Staff Report & Recommendation

Historic Preservation Board

SUBJECT: HPB19-0341, **1751, 1757 & 1775 Collins Avenue.**

Richmond Hotel – 1757 Collins Avenue

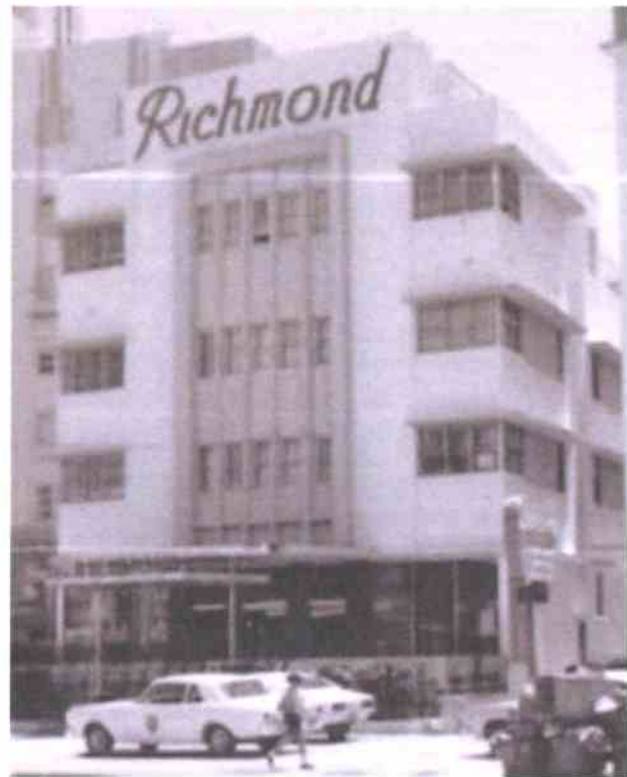
The Richmond Hotel was constructed in 1941 and designed by architect L. Murray Dixon in the Art Deco style of architecture. In 1954, the Collins Avenue façade was modernized, and an attached 7-story addition was constructed at the rear of the building. Modifications to the primary façade included: the construction of a 1-story penthouse, reconfiguration of the lobby window openings and the introduction of a bi-level porte-cochere at the ground level and monumental signage at the parapet.

The applicant is currently proposing the substantial demolition, renovation and partial restoration of the Richmond Hotel and the construction of an attached 2-story rear addition. The demolition requested includes the rear approximately 84% of the building. Additionally, the façade elements introduced during the 1954 renovation are proposed to be removed allowing for the primary façade to be fully restored to its 1941 Art Deco design. The restoration of all significant architectural features including the reintroduction of original materials and finishes on the Collins Avenue façade will have an extremely positive impact on the historic and architectural character of the district.

Within the original public lobby, the applicant is proposing to retain and restore significant architectural features including the terrazzo flooring and several presumed Art Deco era fixtures including the elevator details and lighting elements. Additionally, the applicant is proposing to remove the non-original wood paneling.
